**Re: Minor Project Refinement No. 12 for the TL 6975 San Marcos to Escondido Project**

## TL6975 San Marcos to Escondido 69 kV Project CPUC Minor Project Refinement Form

**TL6975 SAN MARCOS  
to ESCONDIDO PROJECT**  
**MPR 12**  
**Additional Work Areas**  
**San Diego County, CA**

**ATTACHMENT B**  
**MPR-12 Figure**

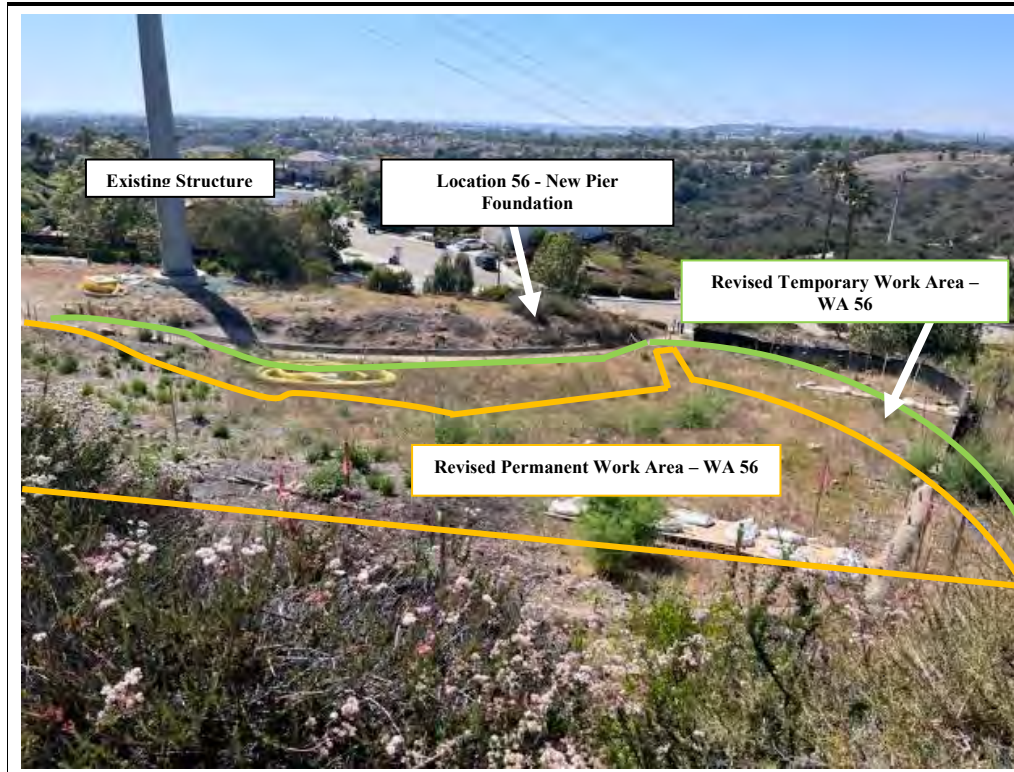
- **Location 56 Revised Work Area (WA 56)<sup>1</sup>:** WA 56 is the revised work pad east of Location 56 which has been shifted approximately 20 feet west. This work area revision prompted the need for a retaining wall to be built within the permanent pad as shown on **Attachment B**. The retaining wall will be approximately 8 feet high and 60 feet long. There is no other change to the approved scope of work at this location, which will include grading the permanent pad and the installation of a brow ditch.

- **WA 56:** During field review it was determined that the approved work area for the permanent pad at Location 56 was partially within the Carlsbad Municipal Water District's easement and needed to be shifted approximately 20 feet west to avoid the easement. This shift prompted the need for a retaining wall to be installed to stabilize the slope of the pad. The revised work limits of the pad are within the SDG&E ROW. It should be noted, taking into account the existing work areas that will no longer be used by the Project, there will be a net decrease of overall work area (-630 sf, 0.01 acre) resulting from this change as demonstrated in the Disturbance Acreage Changes Section below.
